WOLF CREEK

ET 92-0050

Reference: Letter ET 90-0132 dated August 21, 1990, from
F. T. Rhodes, WCNOC, to the USNRC
Subject: Docket No. 50-482: Transmittal of Additional
Information on the Rod Exchange
Methodology for Startup Physics Testing

Wolf Creek Nuclear Operating Corporation (WCNOC) submitted Rod Exchange Methodology for Startup Physics Testing on August 21, 1990. During telephone conversations on August 8, 1991, and August 12, 1991, the US Nuclear Regulatory Commission (USNRC) provided a list of questions on the topical to WCNOC. In a meeting held on January 28, 1992, these questions were discussed between WCNOC and the USNRC, with WCNOC agreeing to submit answers in February, 1992. The questions are listed below with WCNOC's response immediately following each.

Figure 1: Ideal and Actual Rod Positions

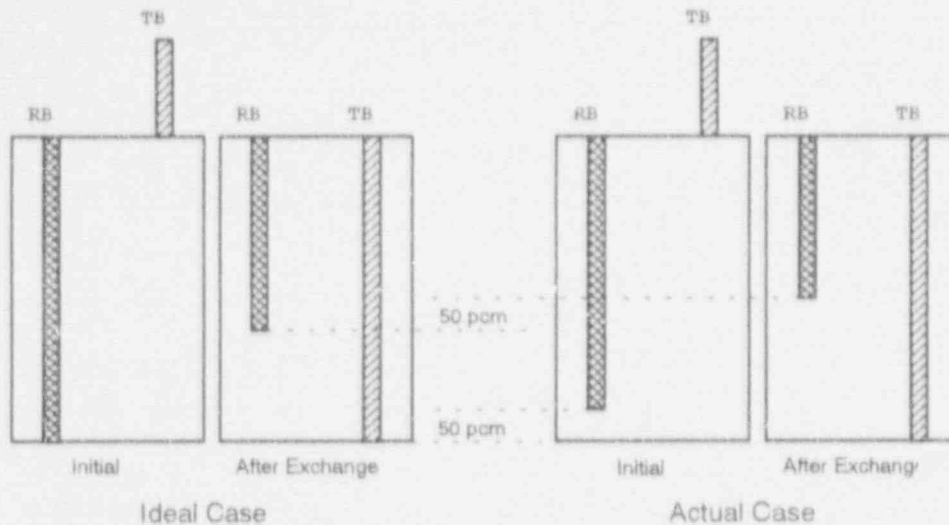
Question 3: Several places in the topical text refer to the position of the Reference Bank being "at or nearly fully inserted" at the conclusion of the boron dilution measurement of the Reference Bank worth. Provide a more detailed discussion regarding the position of the reference bank being at or nearly fully inserted, including what administrative limits WCNOG will use for this position as well as an engineering basis for these limits.

Response: When performing the boron dilution measurement of the reference bank, it is necessary to secure the boron dilution process prior to the reference bank actually reaching the fully inserted position, to allow the coolant to complete mixing and reach an equilibrium boron concentration level. In the ideal case, the final mixing would result in the core being critical with the reference bank exactly at the fully inserted position. In practice, however, this is rarely the case, with the usual final position of the reference bank a few steps above the bottom of the core. In order to correct for this small amount of reactivity, the worth of the final few steps of the rod is typically determined using a standard endpoint technique by temporarily inserting the rod to the fully inserted position and measuring the resulting reactivity change with the reactivity computer. The reactor is then returned to criticality by withdrawing the rod back to its original position.

This correction shows up as the $(\Delta\rho)_{\text{corr}}$ term in Equation (7) of the topical. WCNOG uses guidelines promulgated by Westinghouse regarding the allowable magnitude of this correction, which is to maintain this correction lower than 50 pcm in magnitude. Historically, the average value of this correction from Wolf Creek Generating Station (WCGS) Cycles 3, 5, and 6 has been 13.6 pcm. The average of the correction from WCGS Cycle 1 was 34.2 pcm. Note that although the correction from Cycle 1 was larger, this is to be expected since Cycle 1 was a completely fresh core with associated higher differential rod worths near the ends of the core. The average rod position for these corrections from WCGS Cycles 1, 3, 5, and 6 was 25.8 steps withdrawn.

The effect of beginning with the reference bank slightly above the bottom of the core will be to cause the measured critical height of the reference bank to be higher. If the reference bank begins at a position 50 pcm from the bottom of the core, the new critical height will be at a position which corresponds to 50 pcm higher in the core.

In Figure 1, the new critical height is 50 pcm higher than the ideal case critical height. The actual step difference will be different for each rod bank, depending on the differential rod worth of the shadowed reference bank in the region near the critical height. For rod banks which have a critical height very near the top of the core, it is possible that this variation in critical height could be quite significant, since the differential rod worths can be low in this region. However, for all cases, the actual worth difference will still be 50 pcm, regardless of how different the new critical height may be.
